TOWN OF NEWBURGH PLANNING BOARD TECHNICAL REVIEW COMMENTS

CUMBERLAND FARMS

16-05

30 MARCH 2016

DEMOLITION PLAN

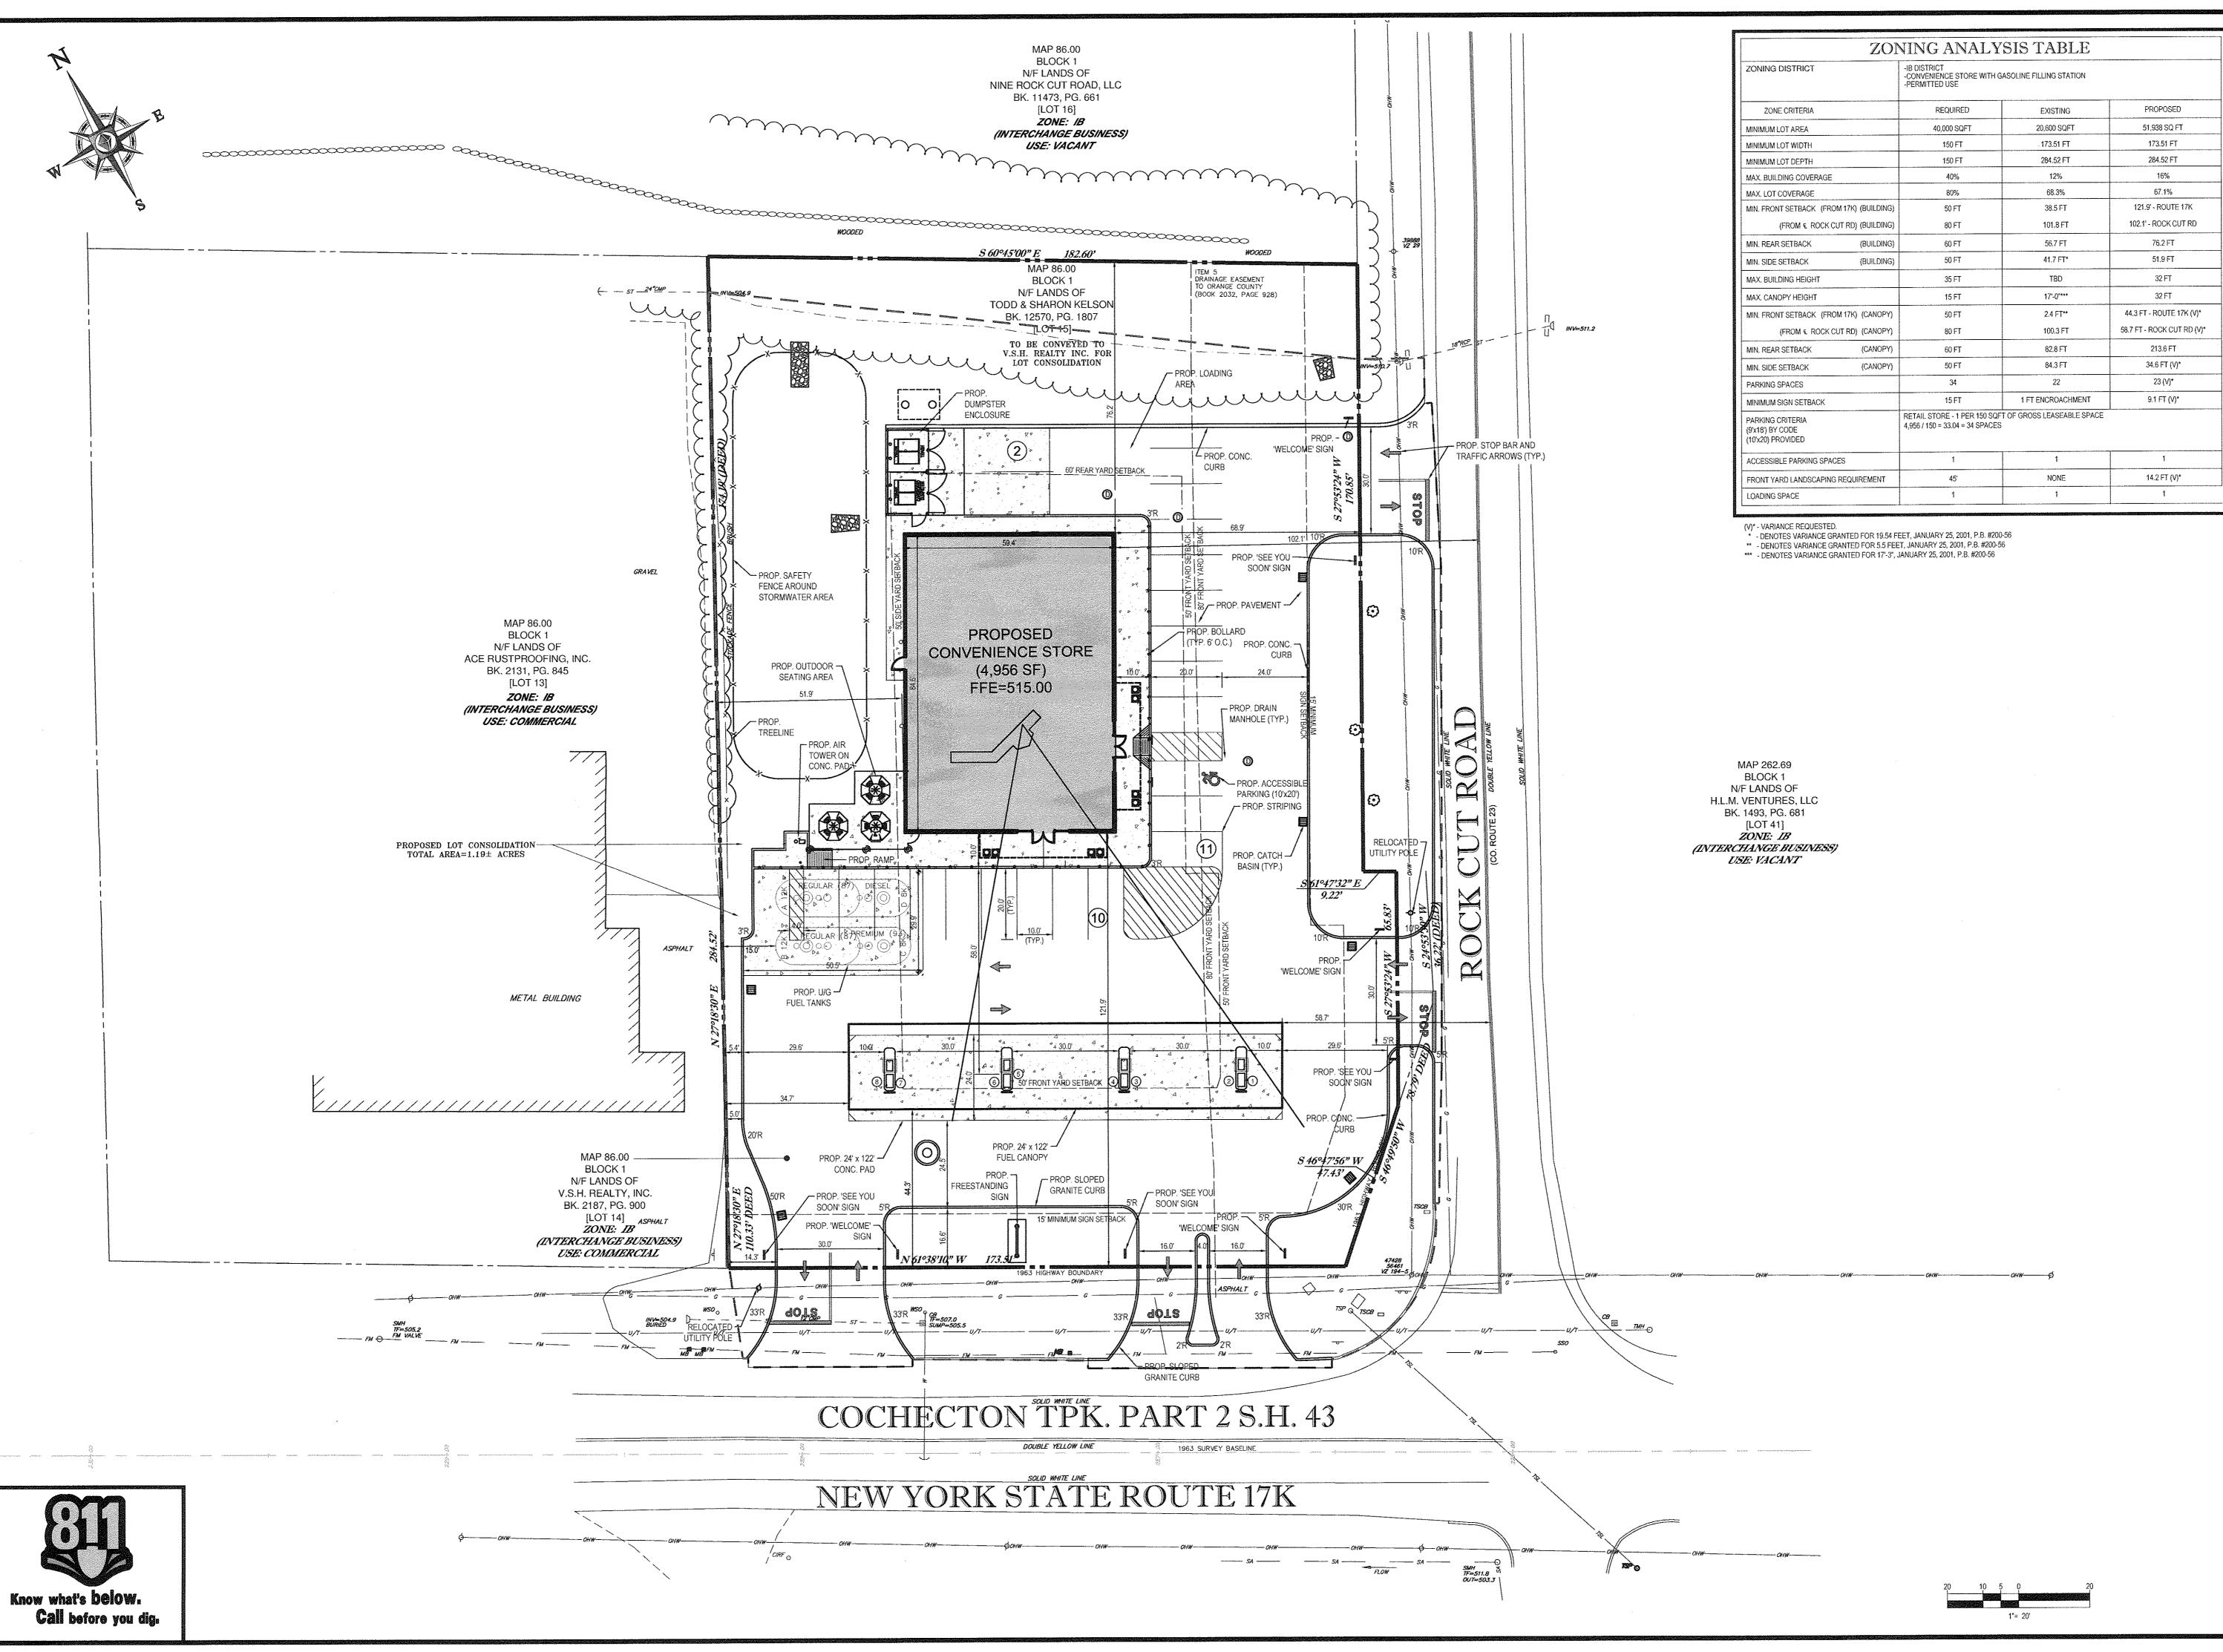
- c) Front Yard Landscaping Requirement
 - d) Signage Locations in Front Yard
 - e) Side Yard for Canopy
 - f) Number of Required Parking Spaces
- 13. Notes on the Demolition Plan should be added requiring a demolition permit from the Town of Newburgh Building Department for removal of any and all structures. In addition a permit is required for removal of existing petroleum bulk storage tanks.

SITE PLAN

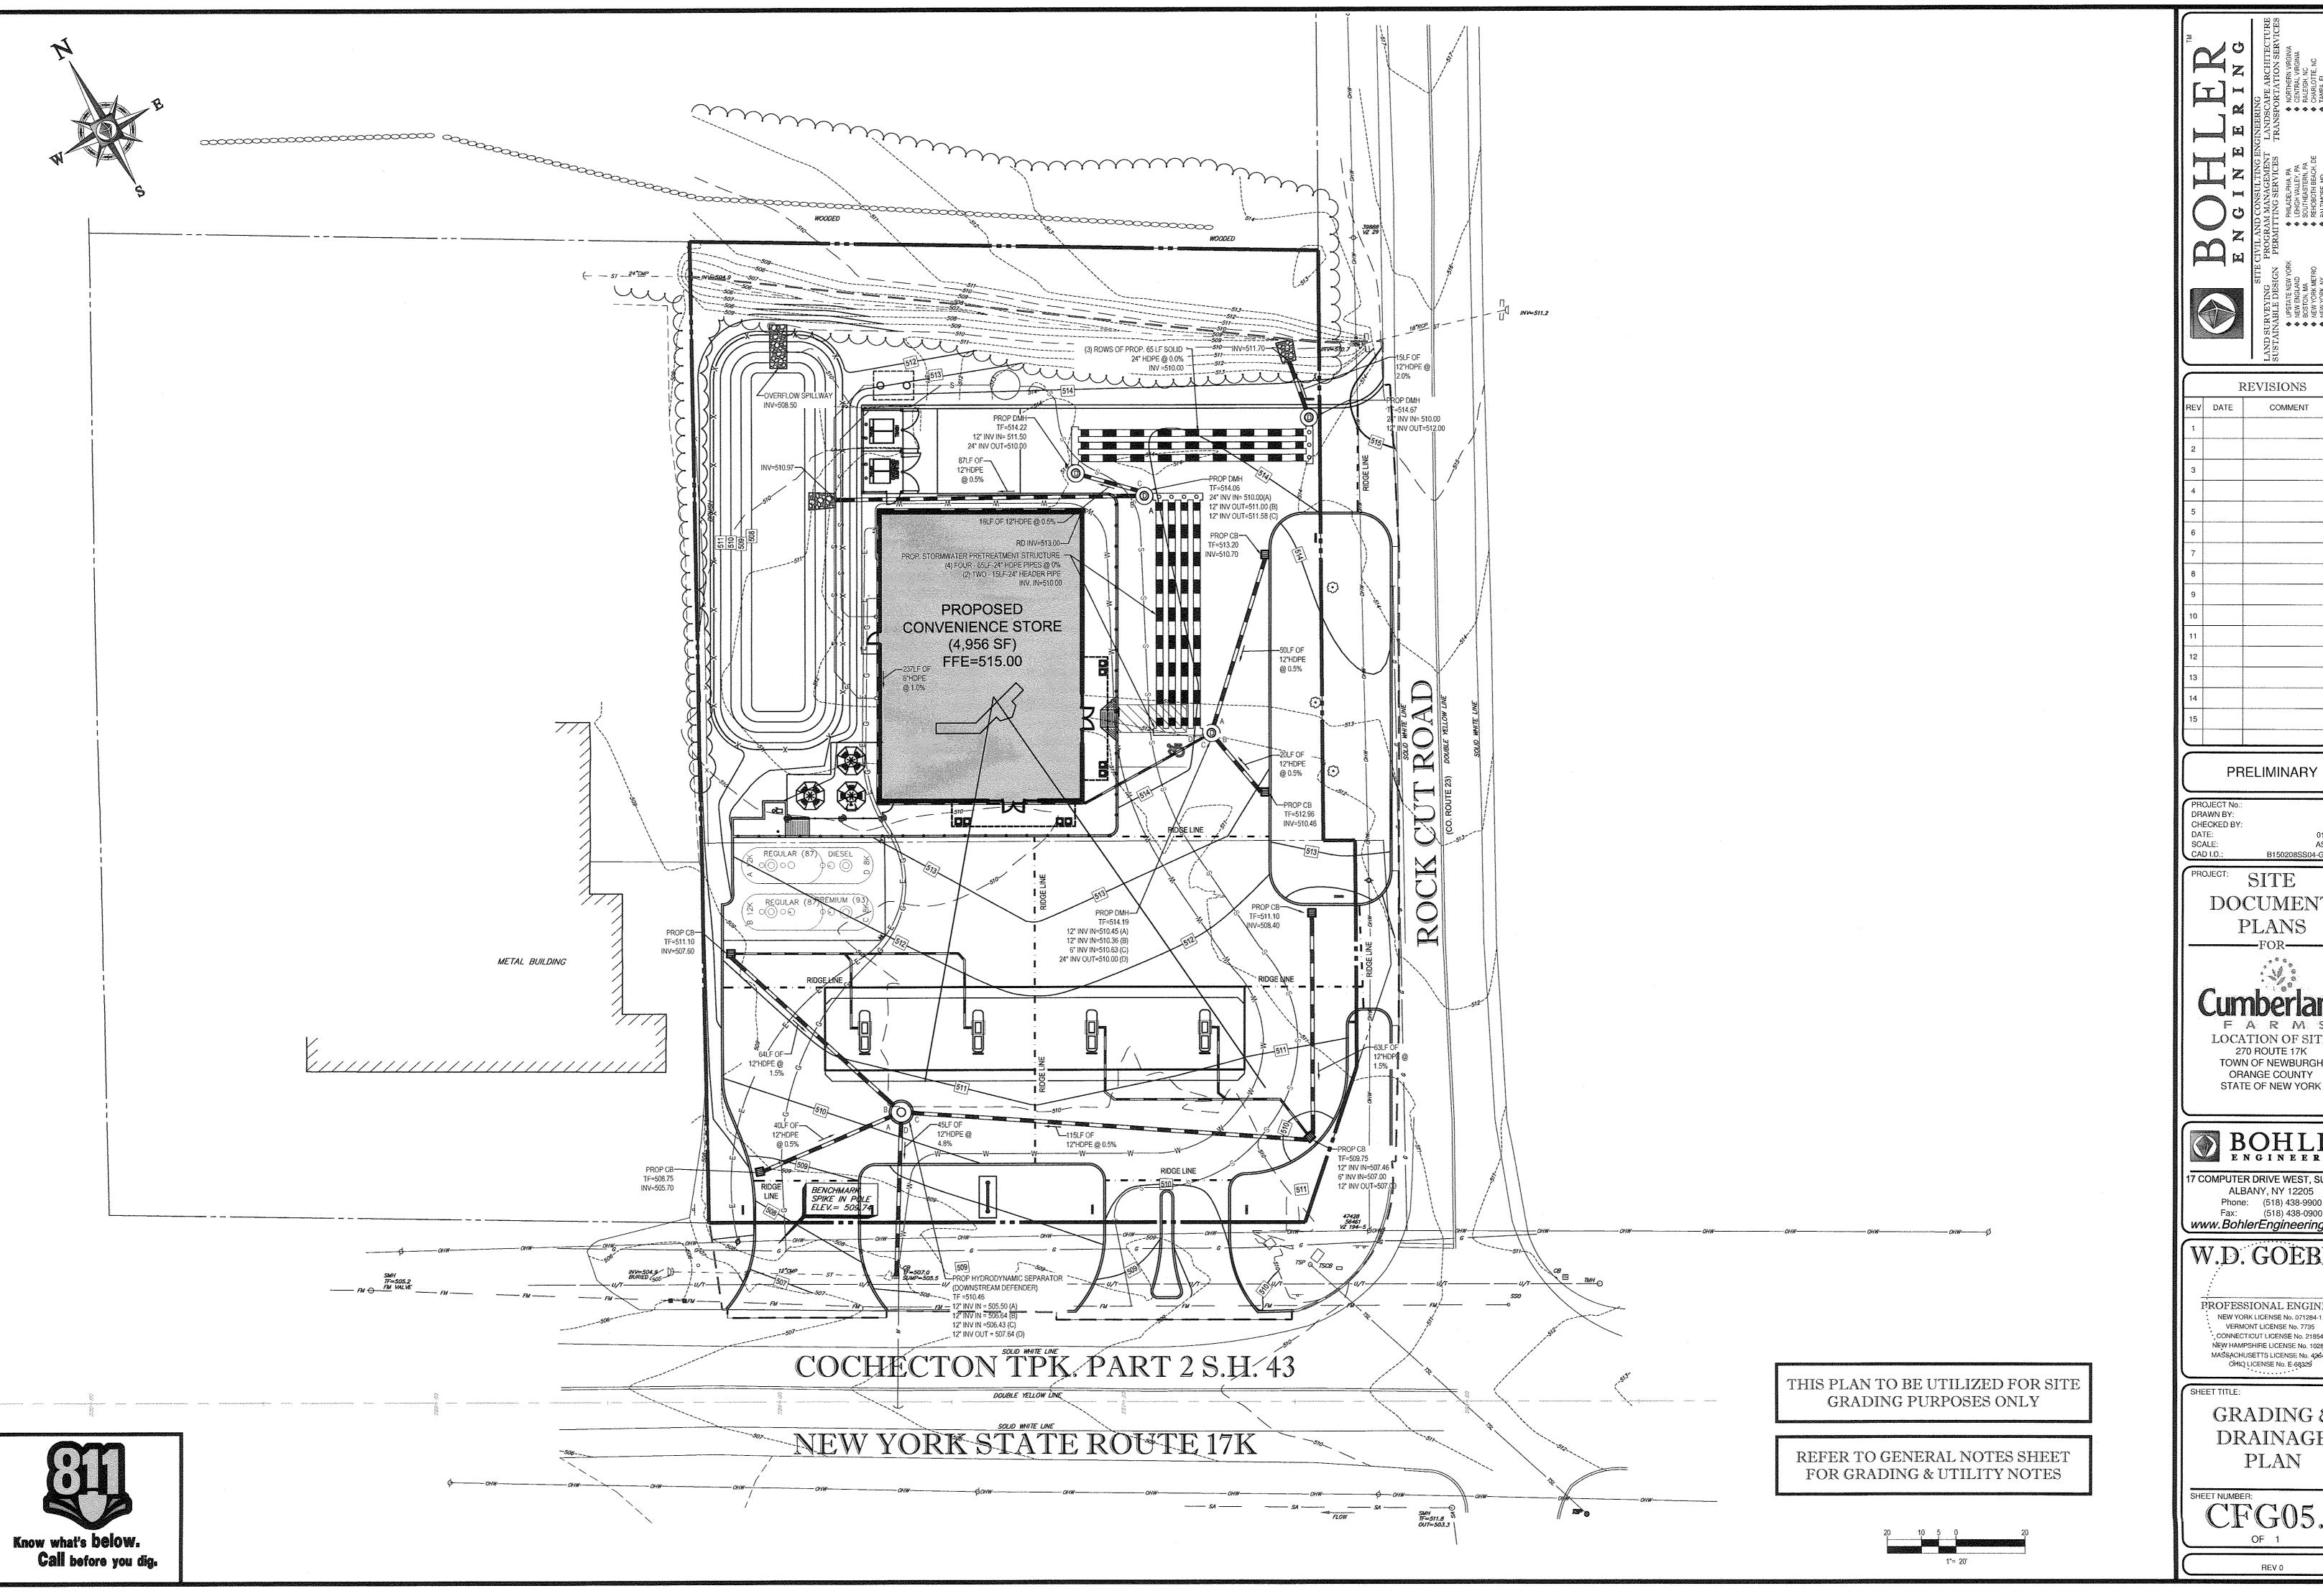
- 14. Parking spaces are depicted as 10x20. Town of Newburgh parking spaces are 9x19 with a double stripe pattern. Striping pattern details should be added to the plans.

GRADING & DRAINAGE PLAN

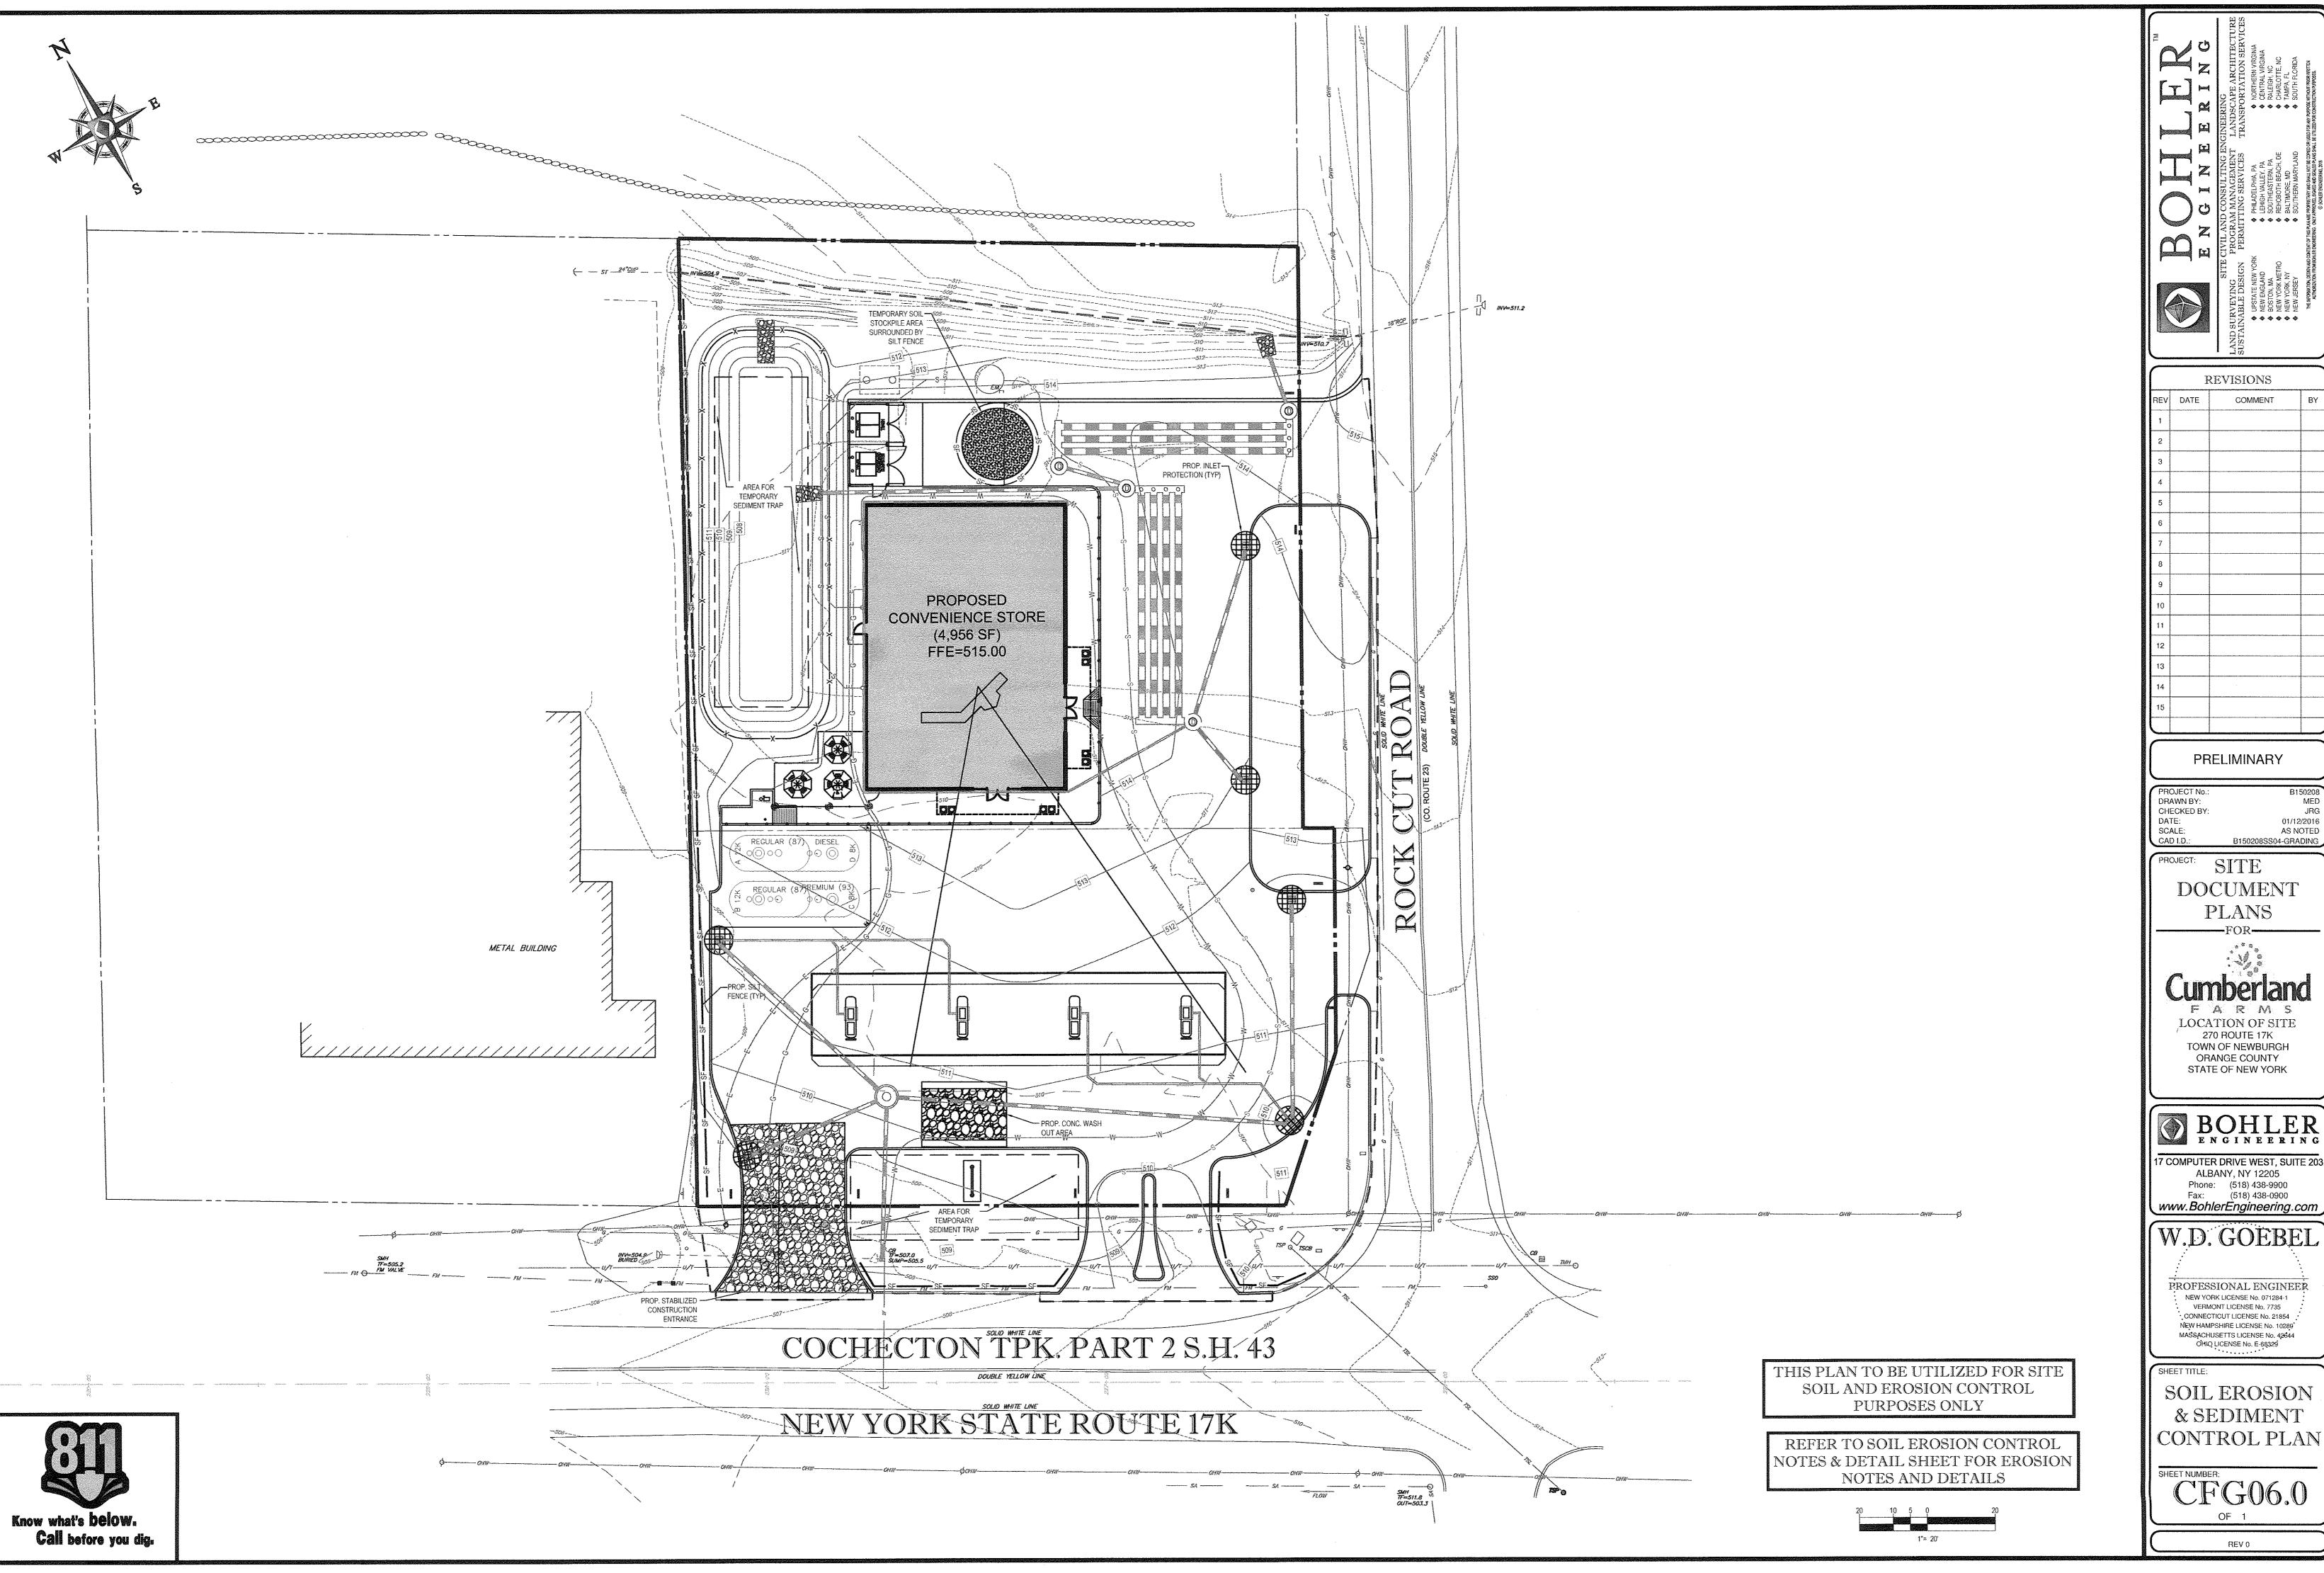
- 15. Sizing information for the proposed grease trap should be provided.
- 16. The design depicts 12 inch diameter pipe. 15 inch Stormwater pipe is the minimum permitted in the Town of Newburgh.

- 17. A temporary sediment trap is identified in the DOT right of way. This should be addressed with the DOT during permitting.
- 18. Drainage Plan identifies "ridgelines" on the site. These appear to conflict with the proposed grading. Discharge to the State Highway will occur based on the proposed grading.
